City of Carlisle, Iowa  
Planning and Zoning Commission  
Regular Meeting  
March 15, 2021  
7:00 P.M.  
Carlisle City Hall

RE: **Danamere Farms Plat 10 – Construction Plan Review**  
**Carlisle, Iowa**  
*FOX Ref No: 8666-03C.259*

FOX Engineering has completed the second review for of the Danamere Farms Plat 10 (formerly Danamere Plat 9) Construction Plans, dated March 10, 2021 and offer the following comments:

# DANAMERE PLAT 10 CONSTRUCTION DRAWINGS

**WATER MAIN  
PLAN & PROFILE**

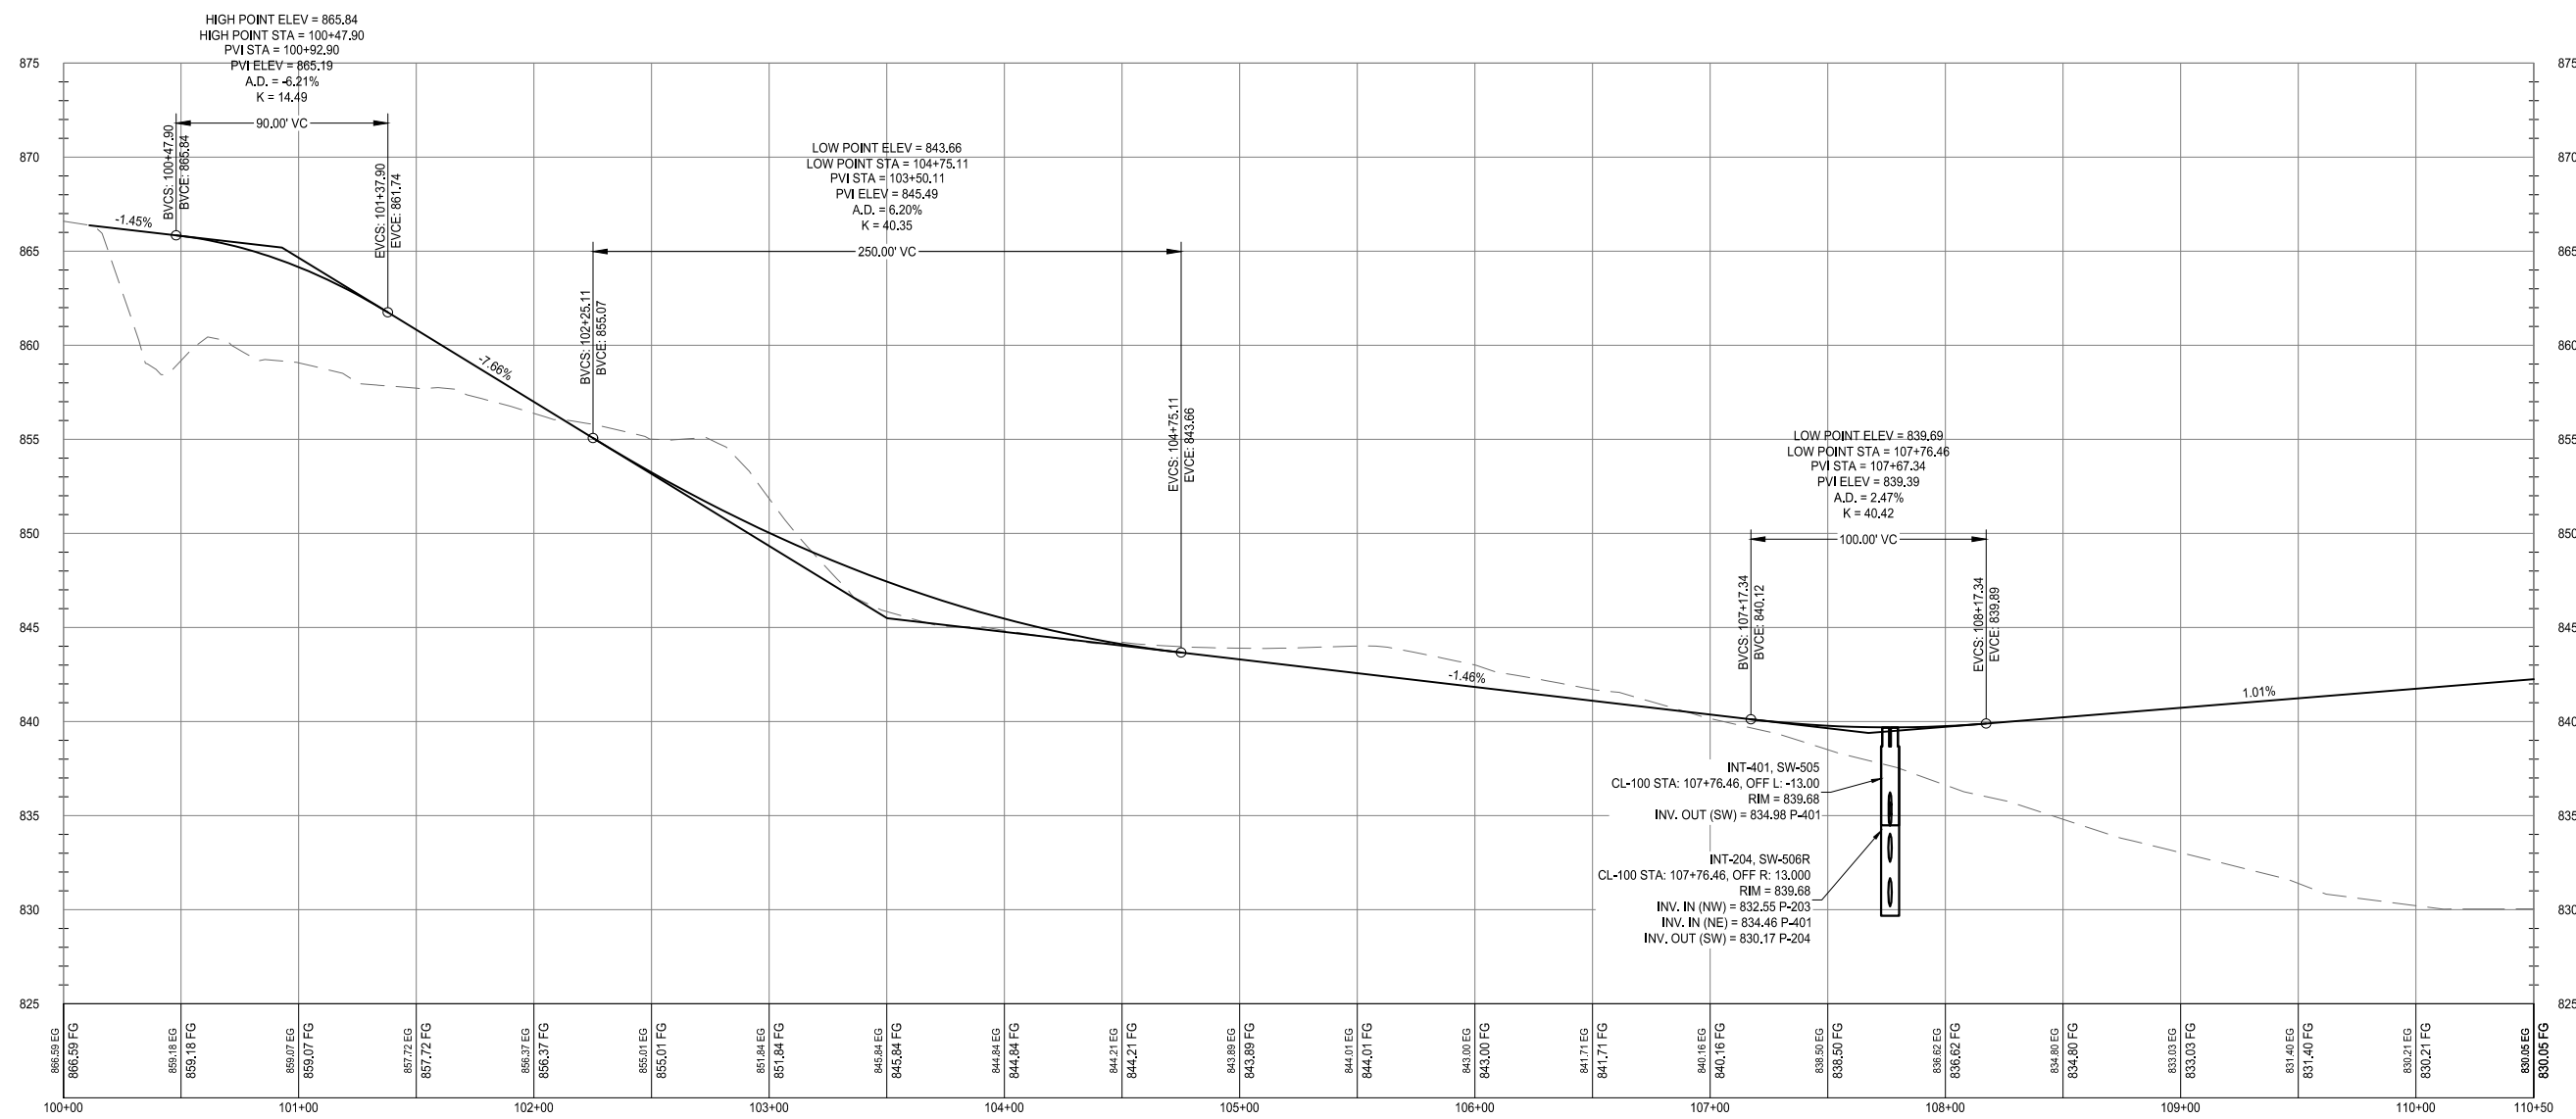
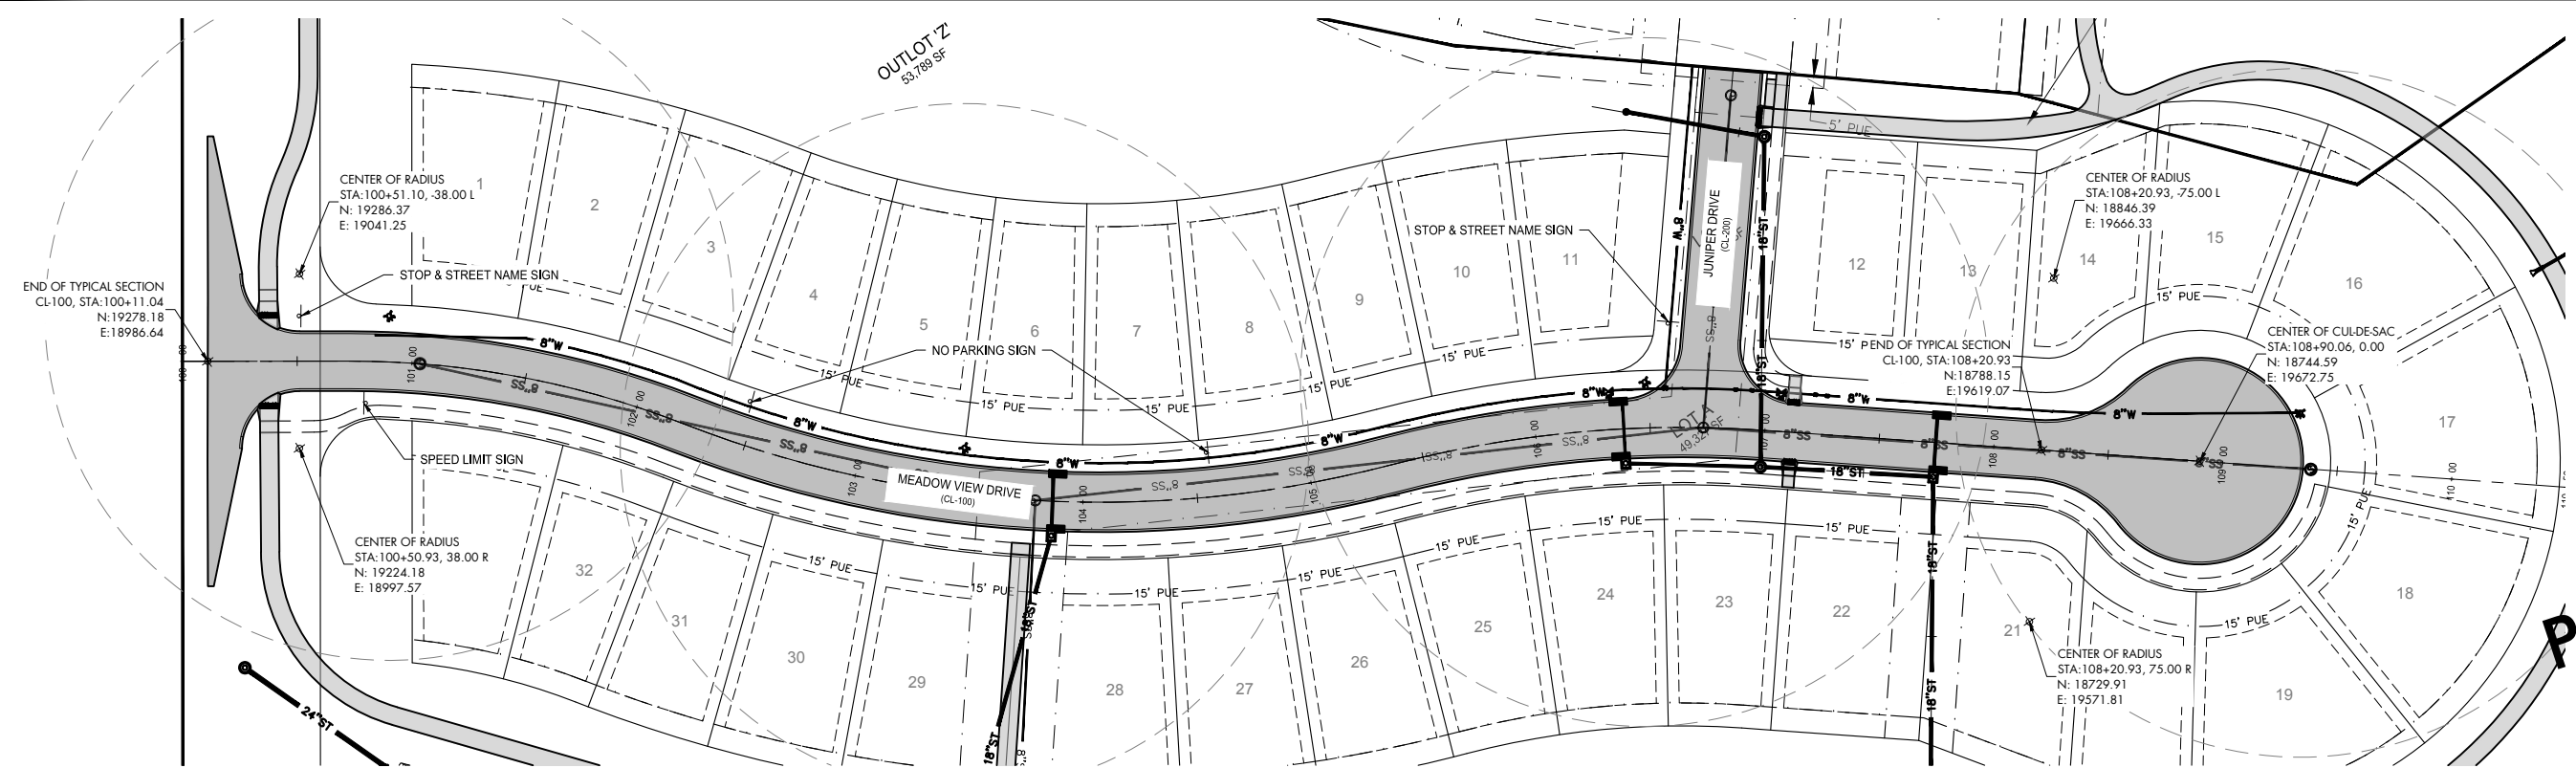
### **Sheet 10 – Water Main Plan and Profile**

15. Please clarify that the vertical deflections around the storm sewer shown on this sheet will have restrained joints. Restrained joints should be placed from STA 105+83 to STA 106+63 (20-ft each way of the bends) or as otherwise determined by Engineer.
16. Please include the following language when placing a storm sewer over water main or less than 18-inches under an existing water main (per SUDAS):
  - a. Where the storm sewer crosses over or less than 18 inches below a water main, locate one full length of sewer pipe of water main material or reinforced concrete pipe (RCP) with flexible gasket joints meeting ASTM C 443 so both joints are as far as possible from the water main

DRAWING NO. **PAV-02**  
SHEET NO. **12 / 21**

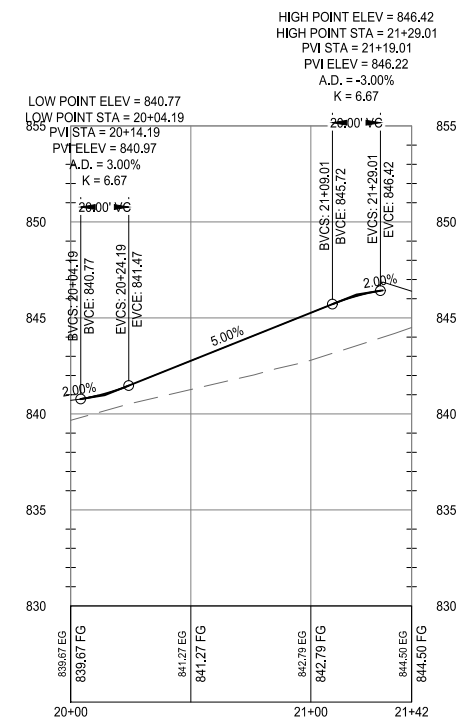
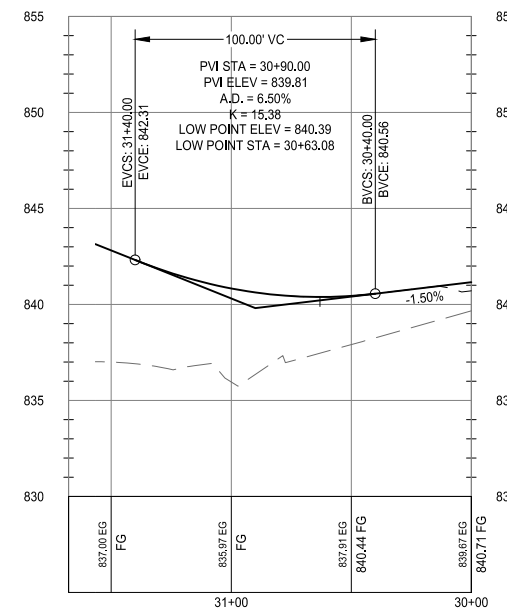
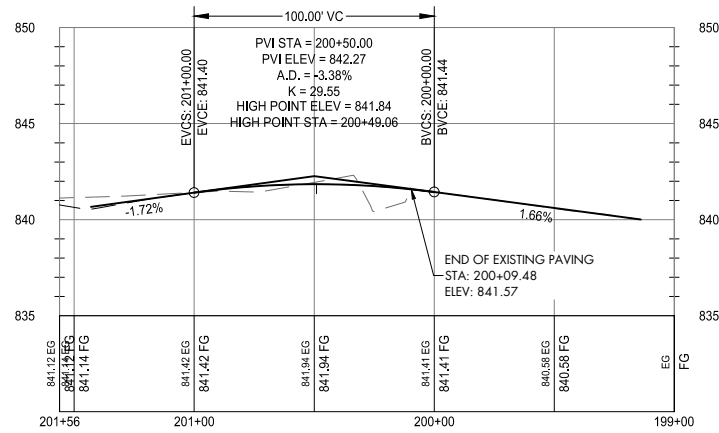
### **Sheet 12 – Paving Plan and Profile**

20. Please show the existing roadway paving in plan view to verify that the roadway is tying in at the same alignment as the existing roadway.
21. There appears to be a jog in the trail vertical profile for trail near STA 21+29. Please review and revise as necessary.

DRAWING NO. SHEET NO.  
**PAV-05 15 / 21**

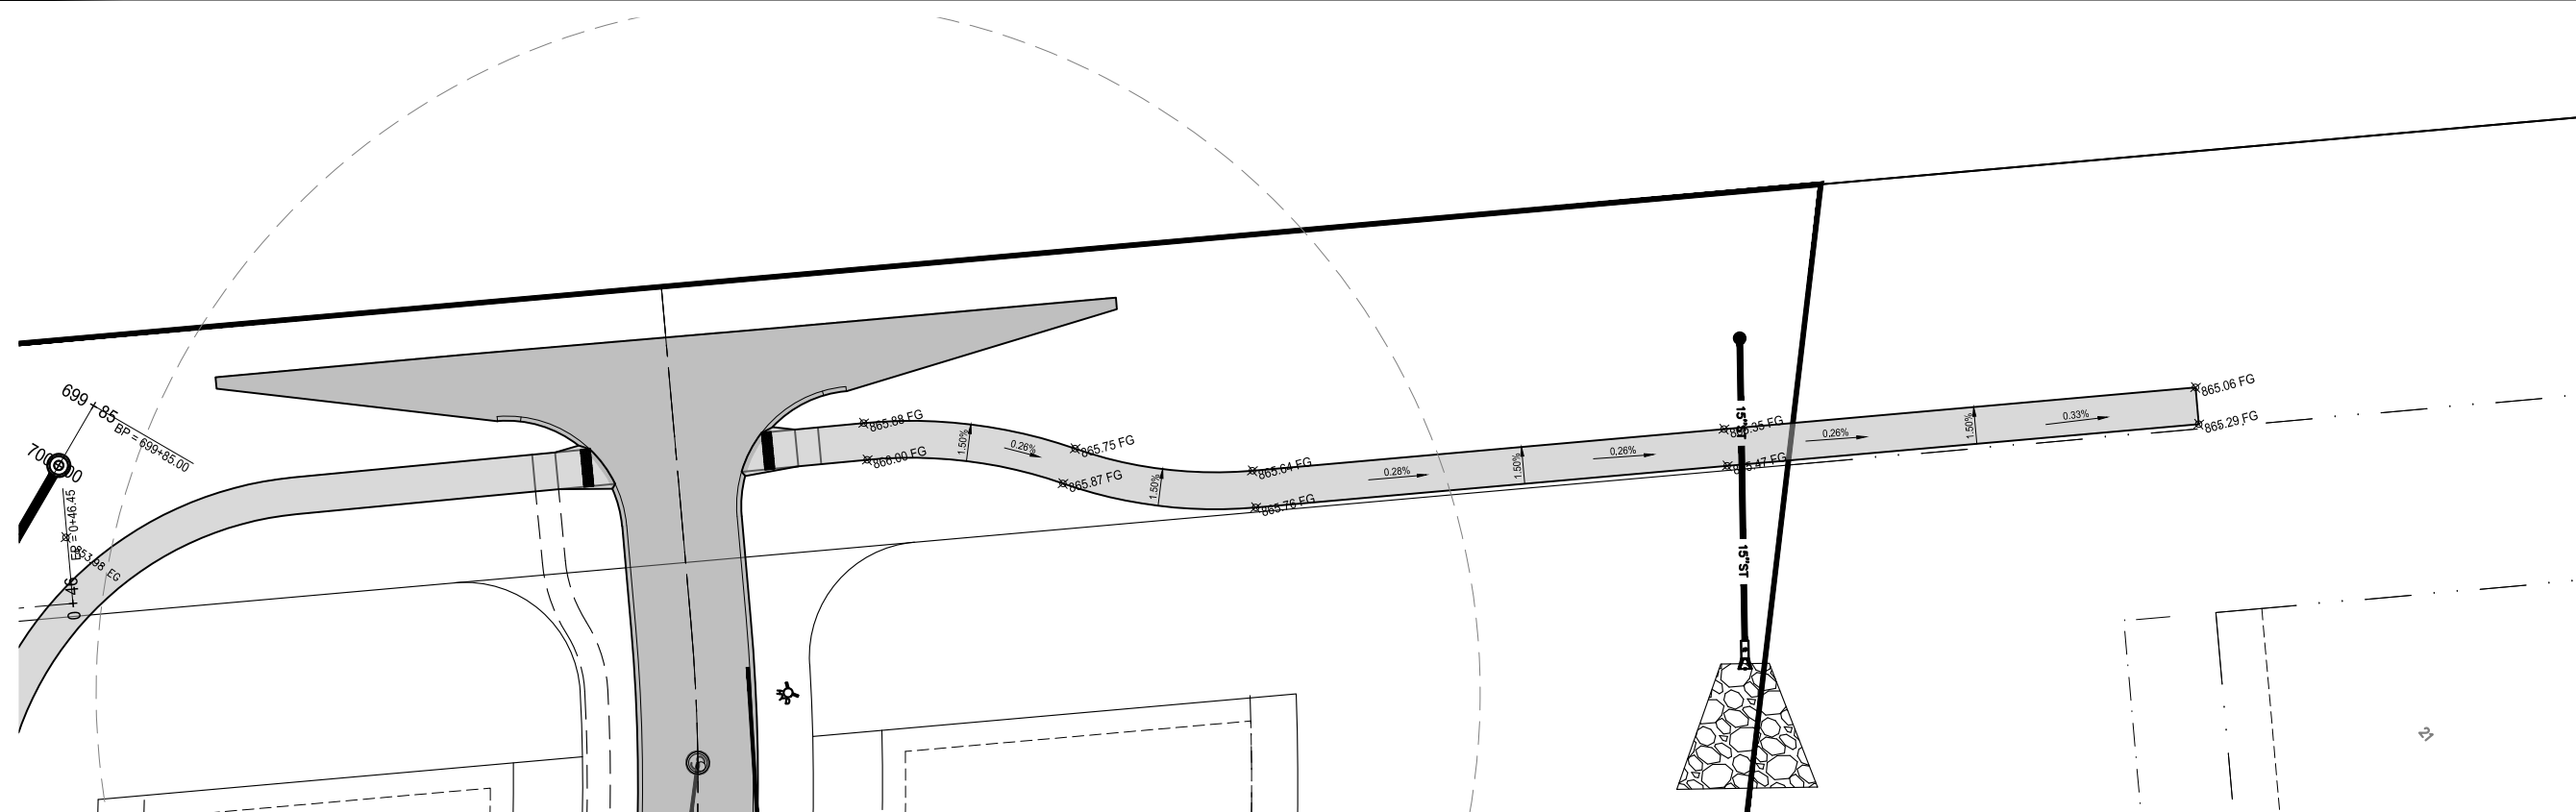
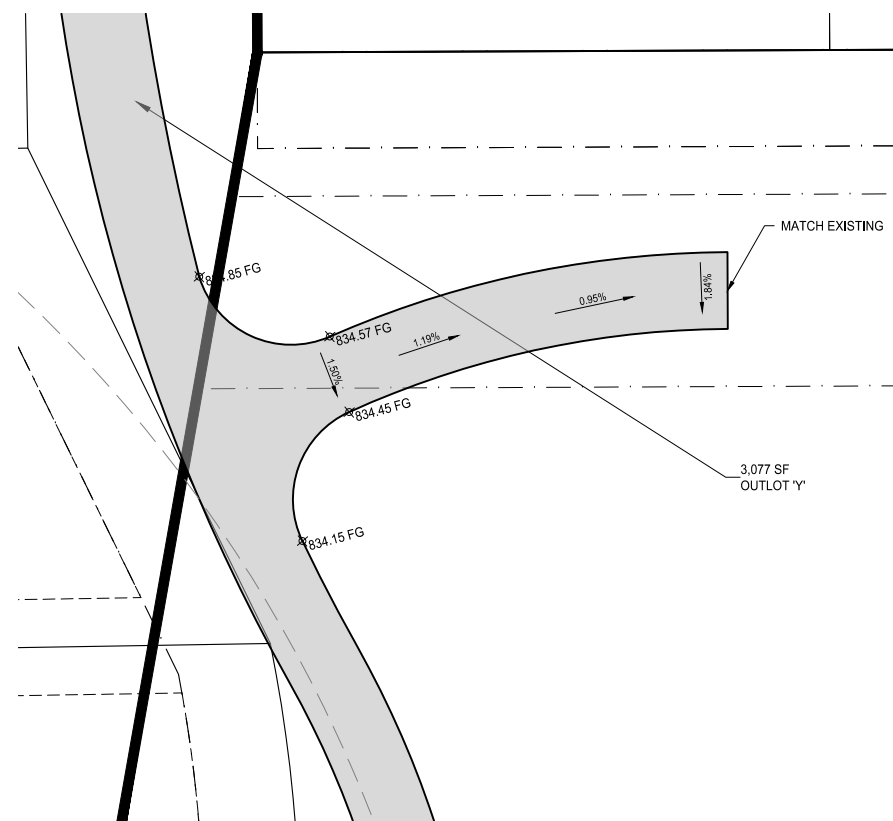
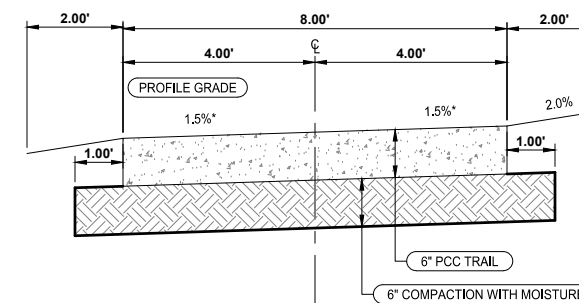
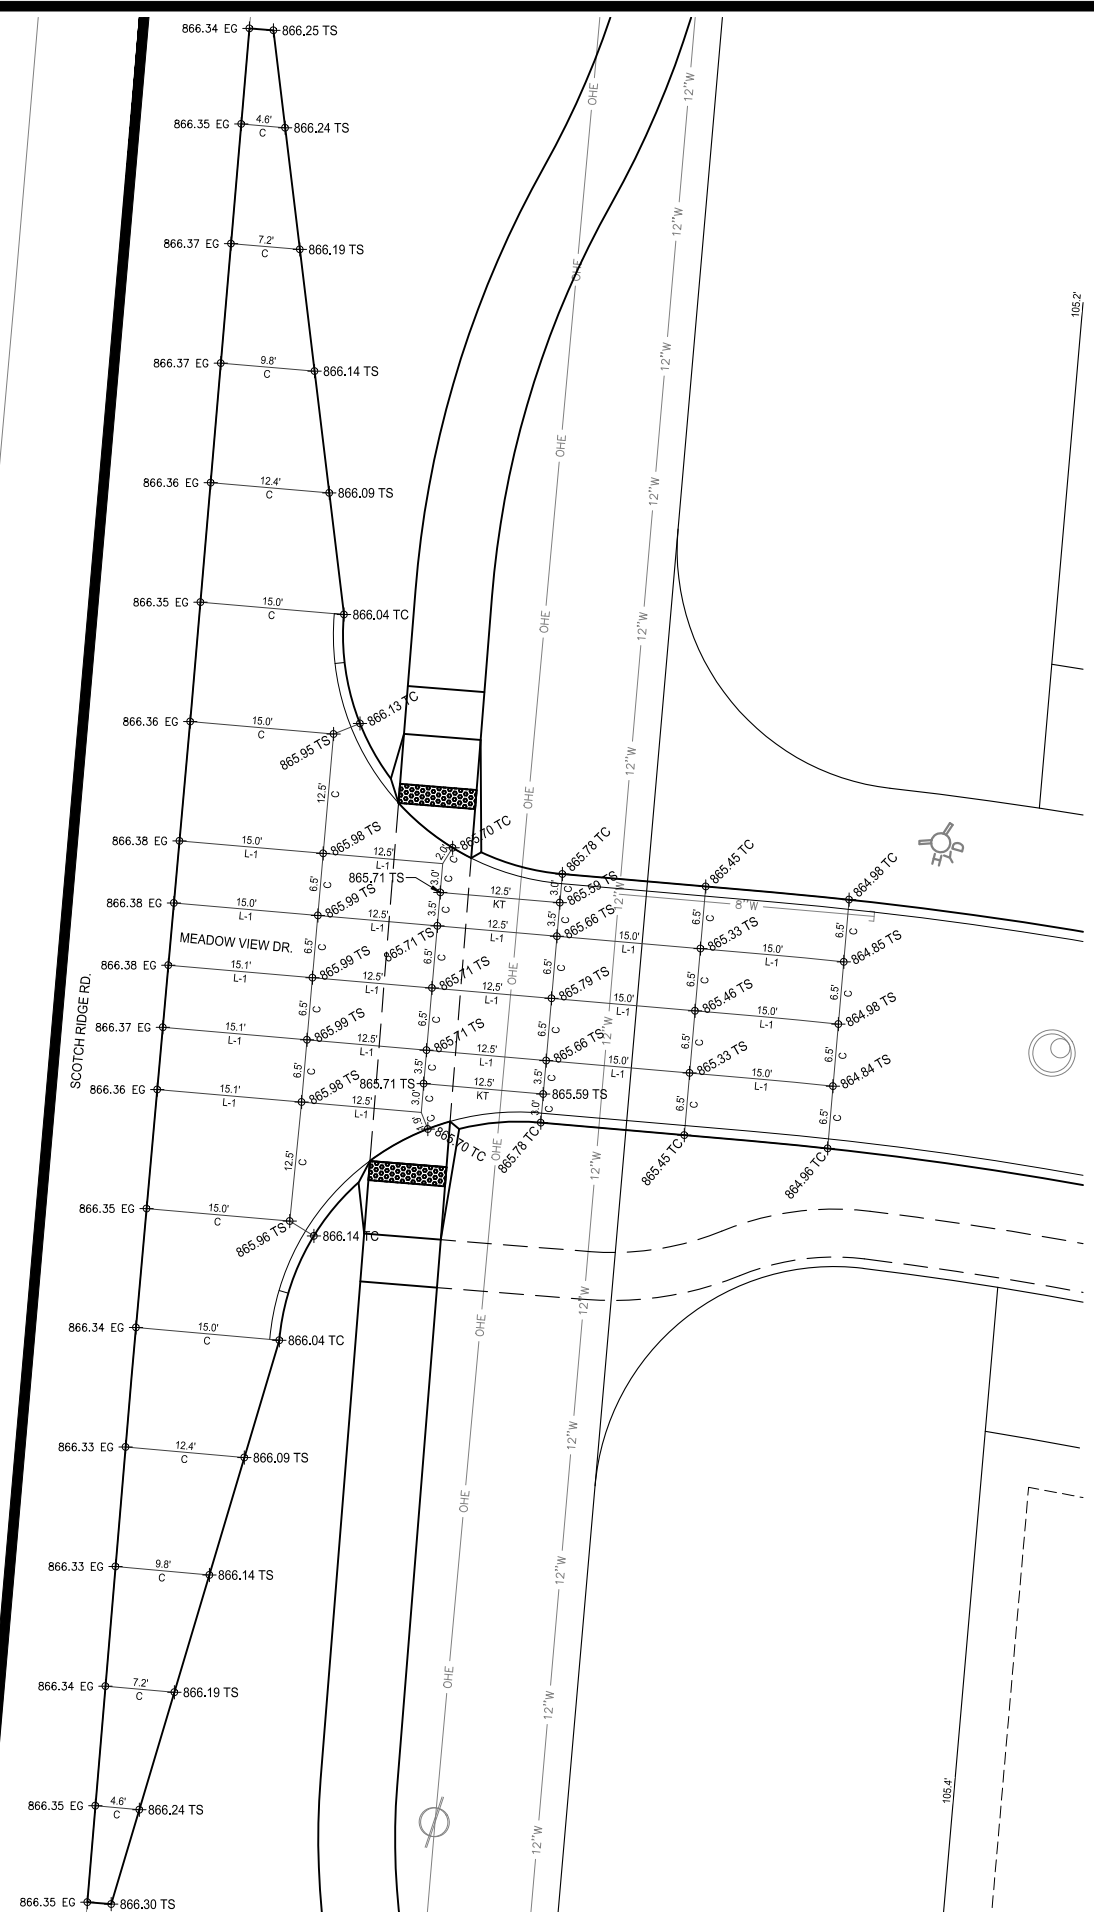
### **Sheet 15 – Paving Trail Details**

22. What is the purpose for the 8' PCC trail detail on this sheet? It appears to match the detail shown on the previous sheet.
23. Please show the existing trail paving in plan view to verify that the trails are matching the existing alignments.
24. Please review the cross slope shown for the end of trail paving. Is this a surveyed match point? The cross slope is shown at 2.9%.
25. Is there existing survey information for the trail stubs? Are the longitudinal grades shown assumed? There is less concern about the trail along Scotch Ridge Road as any grade changes can be made up over a long distance. The shorter trail stub grades may change significantly if the existing trail is not where it was assumed to be.
